ADDENDUM NO. 1

**TITLE: BOONE CENTRAL POST TENSION TRACK AND FOOTBALL FIELD PROJECT
BOONE CENTRAL PUBLIC SCHOOLS**

PROJECT: REGA NO. 121271

DATE OF ISSUE: March 22, 2013

5 4' FENCE with 8' GATE DETAIL
C2.4 NO SCALE

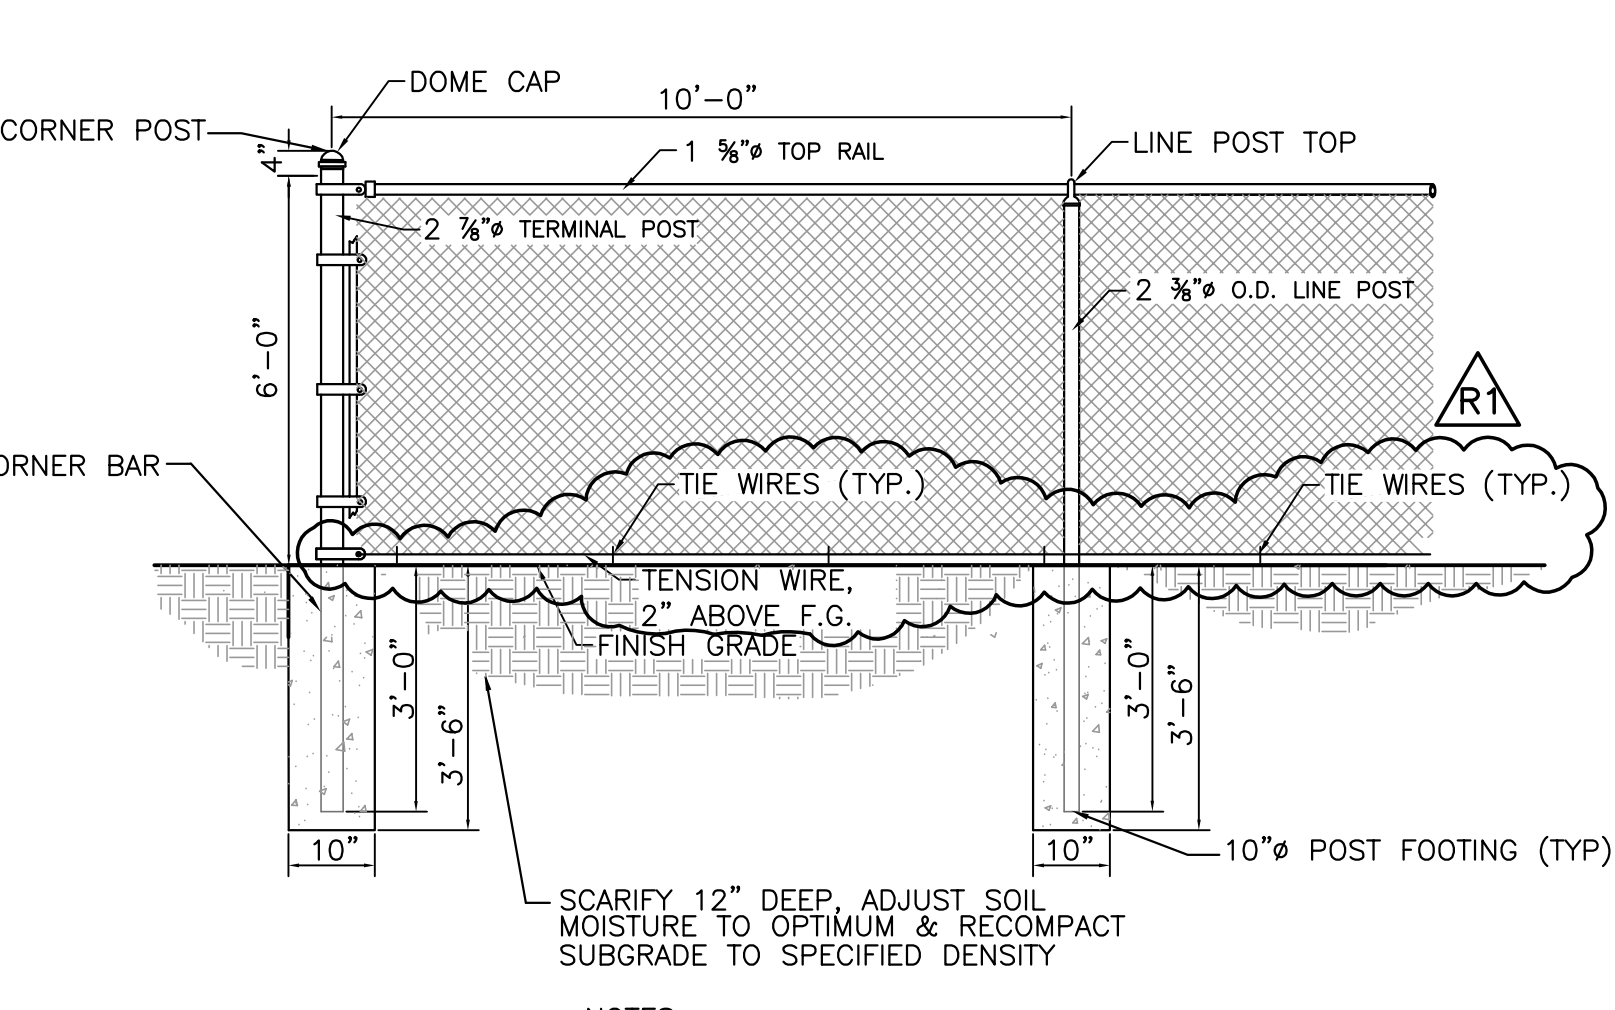
Delete: 2 inch bottom rail on all details

Add: Tension wire on bottom of chain link fence on all details
